Form 3160-5 (June 2019)	UNITED STATES DEPARTMENT OF THE INTERIOR BUREAU OF LAND MANAGEMENT	FORM APPROVED OMB No. 1004-0137 Expires: October 31, 2021
SUNDRY NOTICES AND REPORTS ON WELLS <i>Do not use this form for proposals to drill or to re-enter an abandoned well. Use Form 3160-3 (APD) for such proposals.</i>		5. Lease Serial No. NMNM0438001
		6. If Indian, Allottee or Tribe Name

EOG respectfully requests an amendment to our approved APD for this well to reflect the following changes:

Stella Blue 30 Fed Com 714H

Revised Permit Information 10/24/2022:

WELL LOCATION AND ACREAGE DEDICATION PLAT

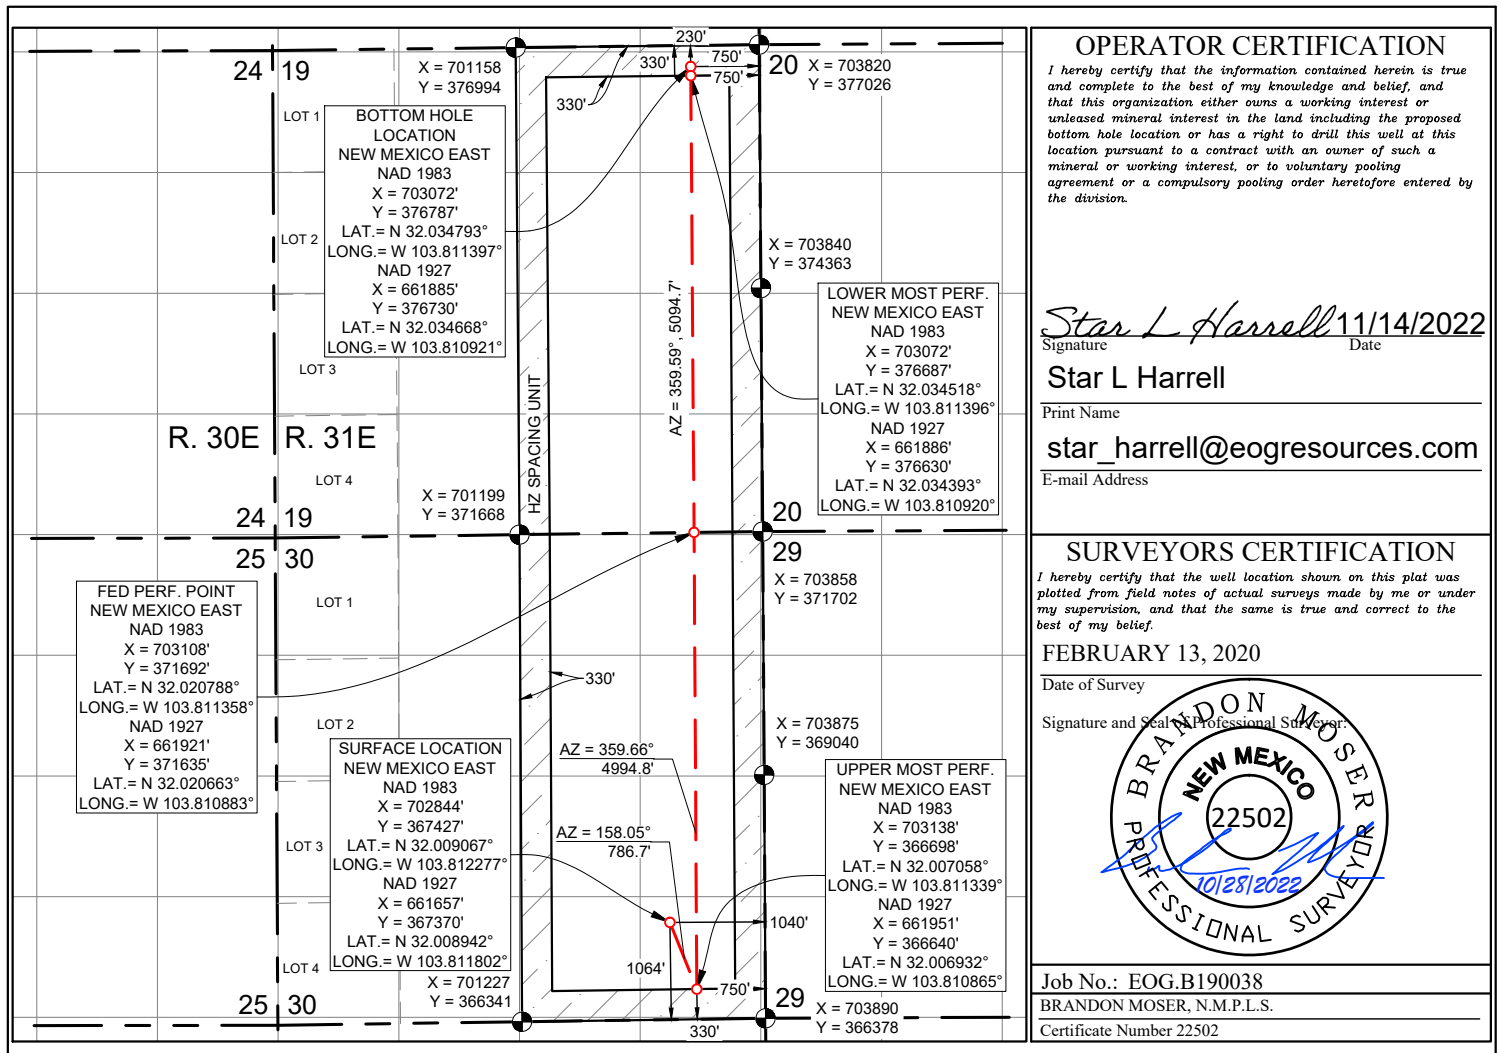
Change BHL from T-26-S, R-31-E, Sec 19, 230' FNL, 660' FEL, Eddy Co., NM, to T-26-S, R-31-E, Sec 19, 230' FNL, 750' FEL, Eddy Co., N.M.

UL or lot no.	Section	Township	Range	Lot Idn	Feet from the	North/South line	Feet from the	East/West line	County
A	19	26 S	31 E		230	NORTH	750	EAST	EDDY
Dedicated Acres 640.00	Joint or Infill	Consolidated Code	Order No.
